BURLINGTON DEVELOPMENT REVIEW BOARD Tuesday June 20, 2017, 5:00 PM PUBLIC HEARING NOTICE

BURLINGTON DEVELOPMENT REVIEW BOARD Tuesday, June 20, 2017, 5:00 PM Contois Auditorium, City Hall, 149 Church St, Burlington, VT AGENDA

To: Development Review Board
From: Ryan Morrison, Associate Planner
Date: June 20, 2017
RE: ZP17-1191HO; 55-57 Howard Street

To: Development Review Board
From: Mary O'Neil, AICP, Principal Planner
Date: June 20, 2017
RE: 79 Industrial Avenue ZP17-1097CA/MA

C1.04

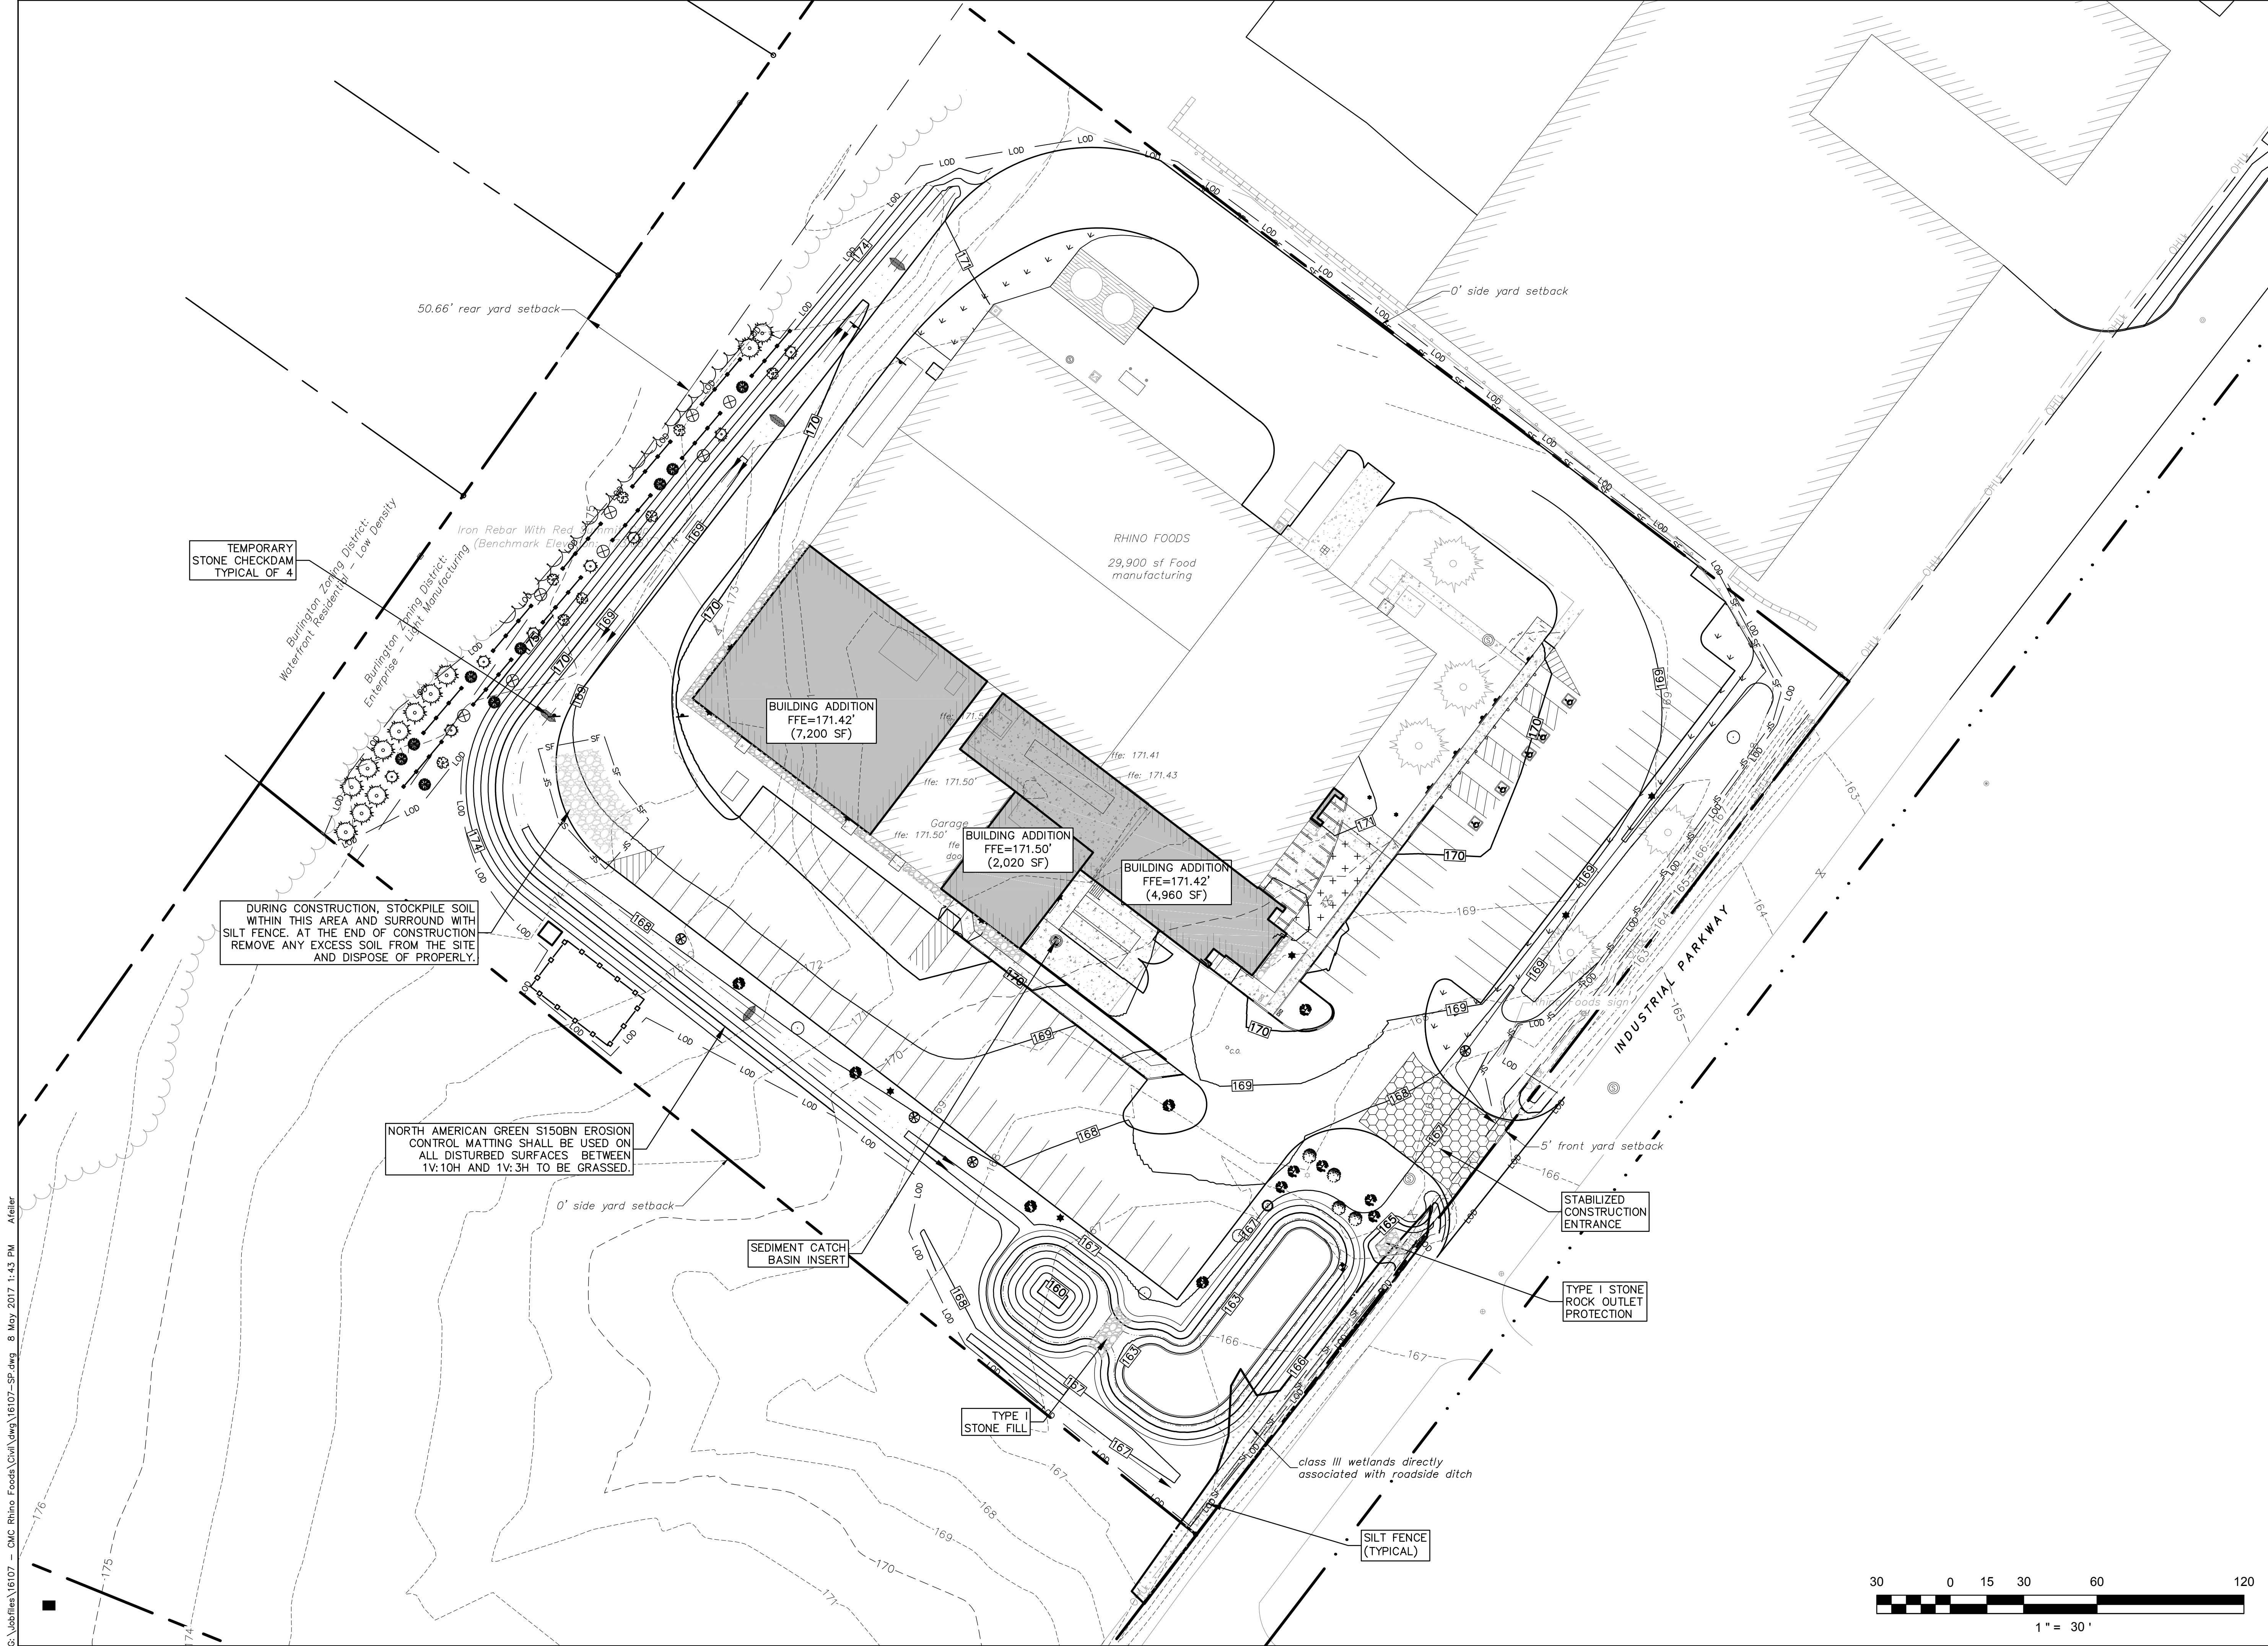
Some grading will be required as part of the development. A retaining wall (not to exceed 3' in height) is included at the loading dock. See Plan C1.04 for specific details. Approval of the Stormwater plan (to assure flow path) is a prior-to-release condition. **Affirmative finding as conditioned.**

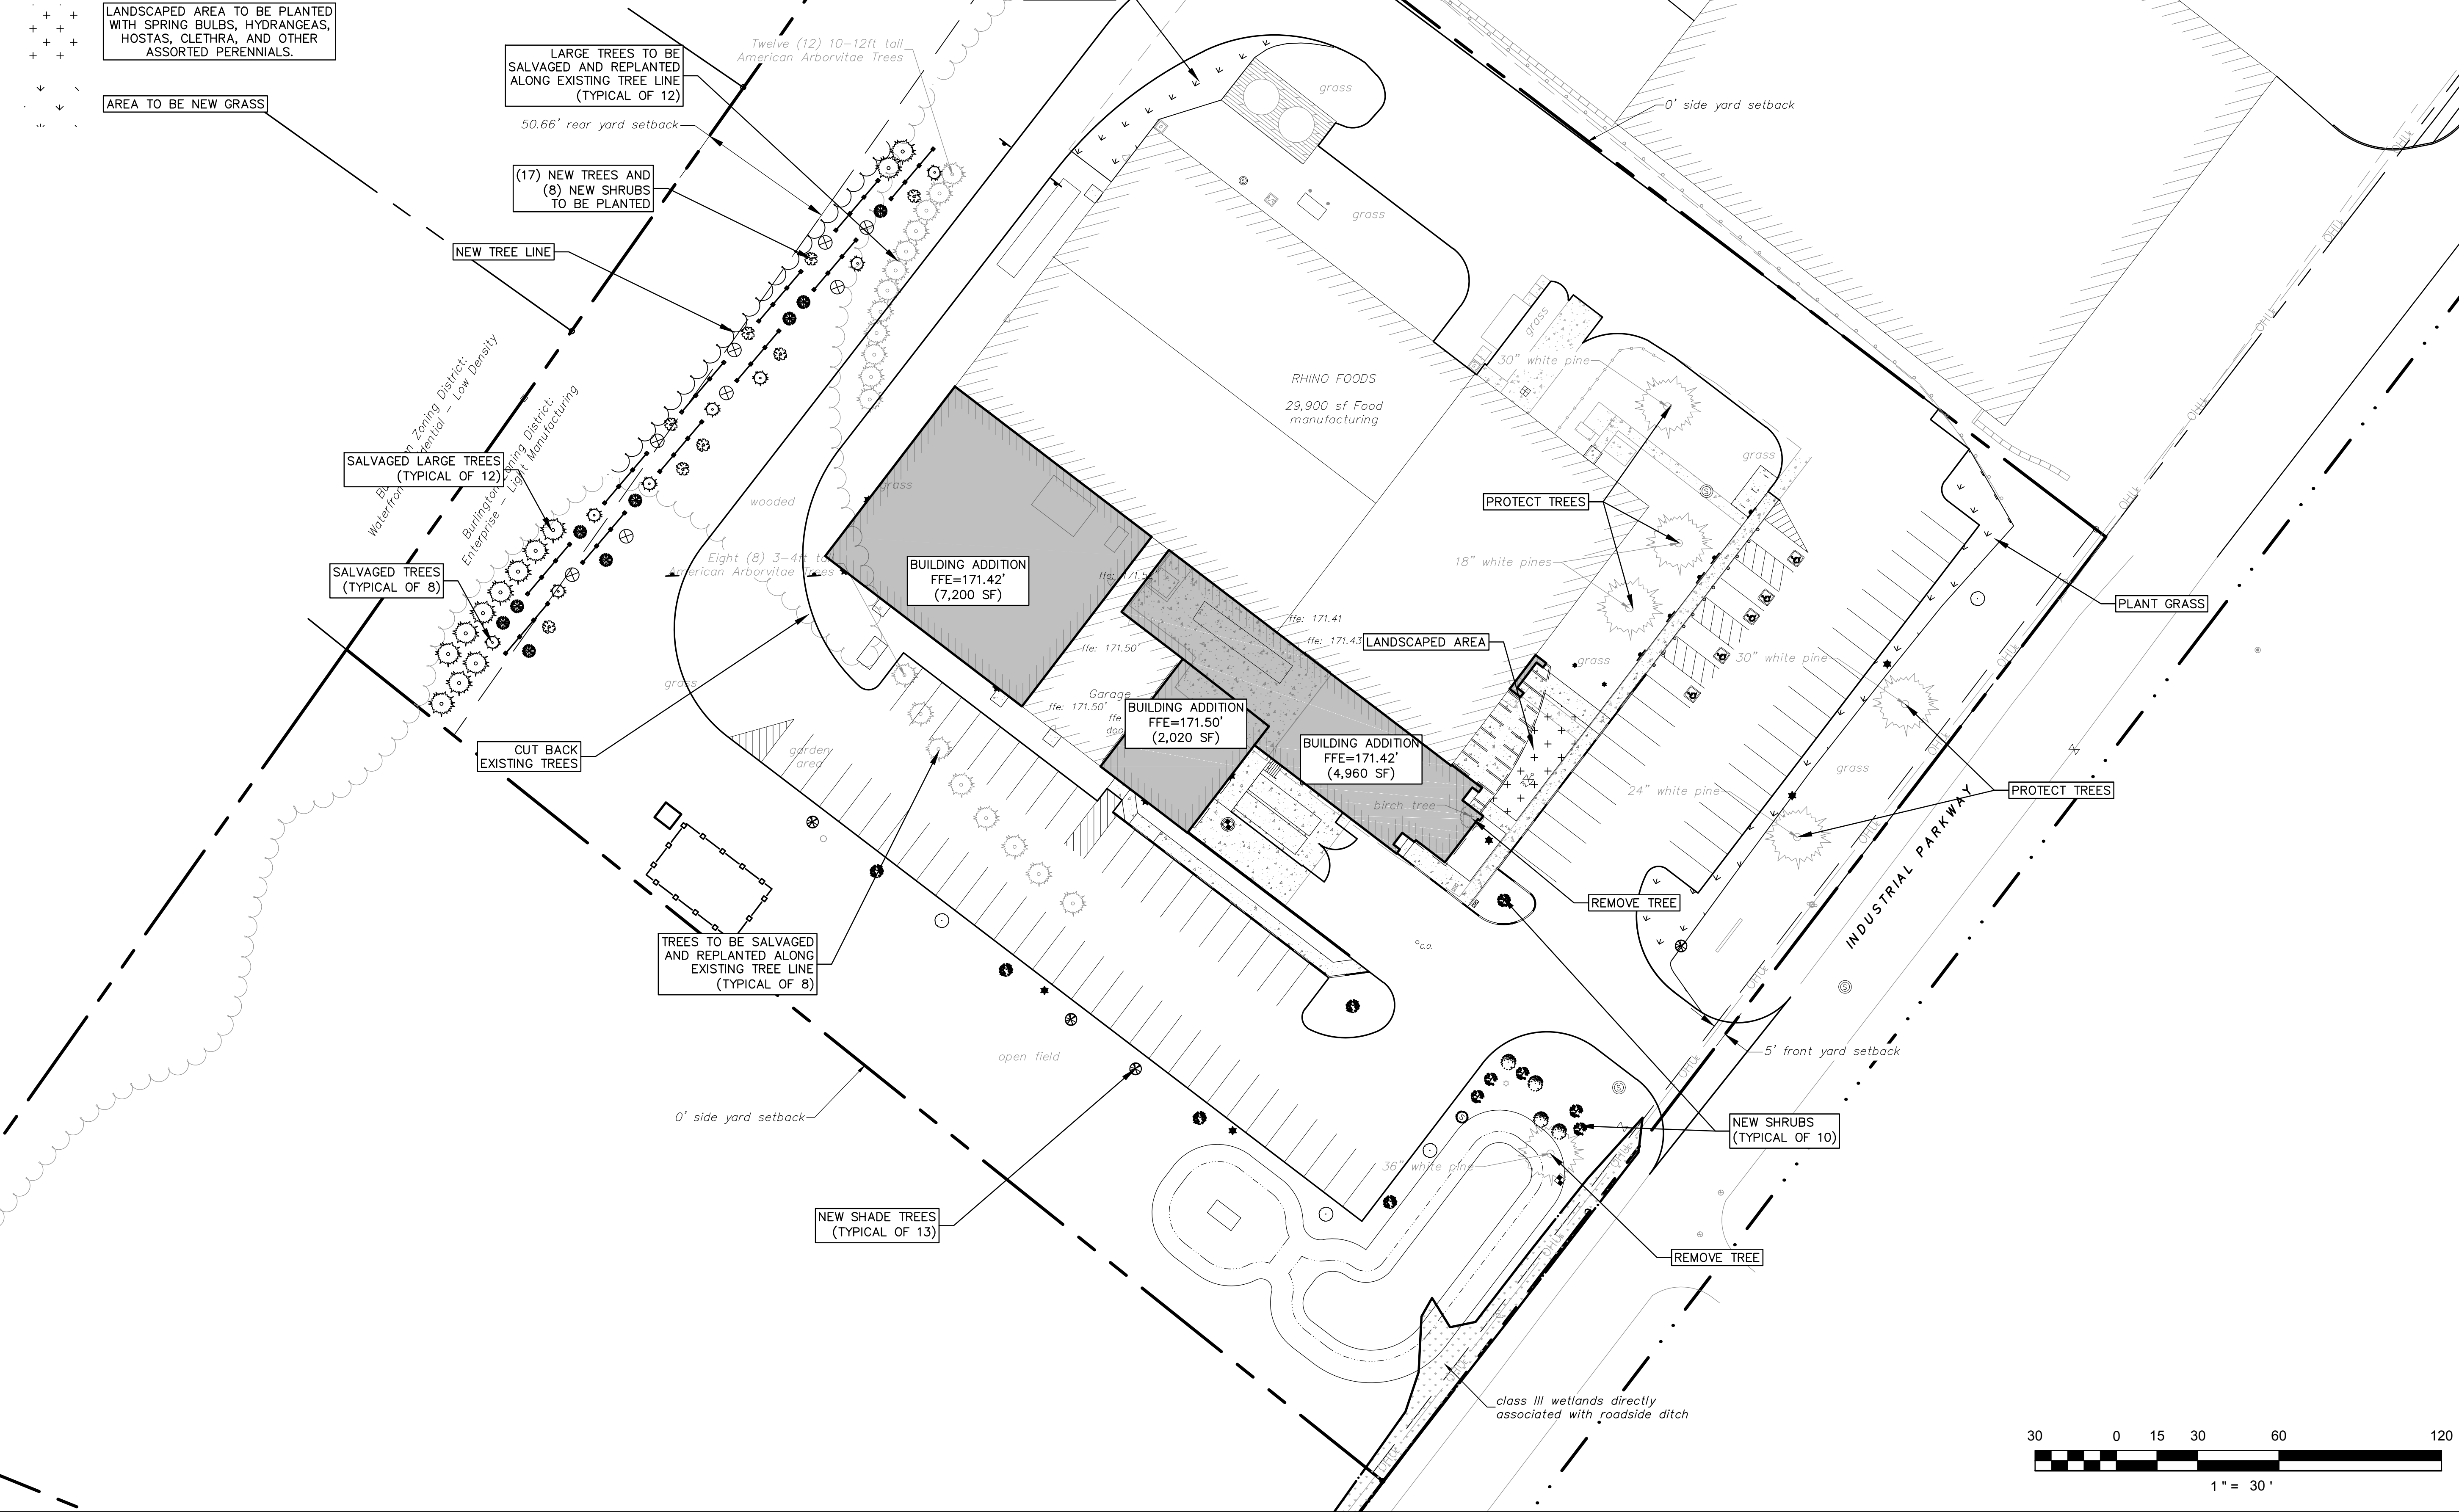
- New plantings, including additional evergreens such as arborvitae, should be added along the northern property boundary in a staggered configuration.

- To the northwest of that line, the area should be left unmanaged to allow understory growth providing for wildlife habitat in that corridor.
- If the fence is to be extended, it should be staggered as well. The fence should be installed in such a way as to avoid additional tree clearing. Tree clearing should be limited to the triangular spot shown on the site plan.

facility is operating and deliveries are scheduled to occur between 8 AM and 8 PM. Another noise concern is the boiler, which is noted to be loud. It was discussed that the boiler is required to heat the water used as part of the sanitation process. Low height landscaping and fencing is proposed along the western property line to help buffer noise from the facility. See sheet L1 for landscaping information.
